Subregional RTEP Committee – Mid-Atlantic FirstEnergy (Met-Ed) Supplemental Projects

February 17, 2022

Update to S1761 Supplemental Project

Need Number: ME-2018-001

Van Reed Substation

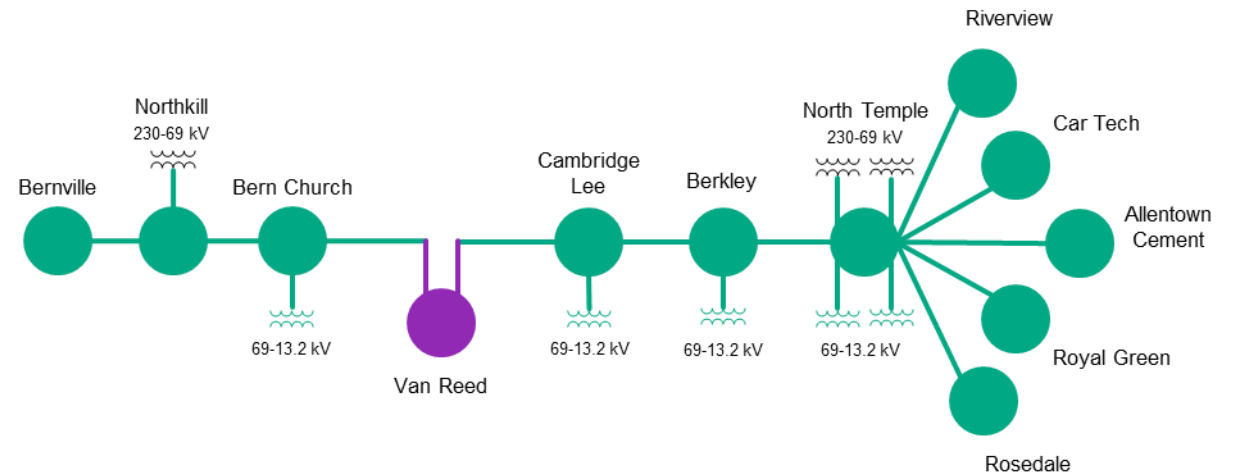
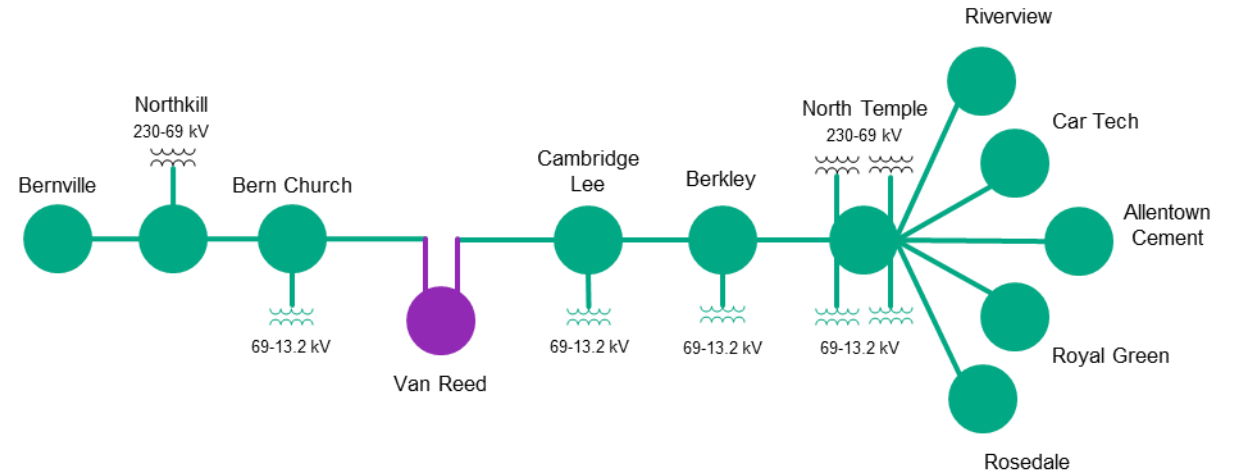
- Construct new Van Reed 69 kV Ring Bus Substation
- Loop the Northkill - North Temple 69 kV line into Van Reed (Approx. 3.8 miles)
- Provide new 69 kV delivery point for customer

- Cost increase due to:
 - Transmission line estimate revisions
 - Substation estimate revisions
 - Transmission line length increased 1.6 miles
 - Transmission line has 0.5 mile of underground construction
 - More detailed engineering completed

Estimated Project Cost: \$33.7M

Projected IS Date: 3/1/2024
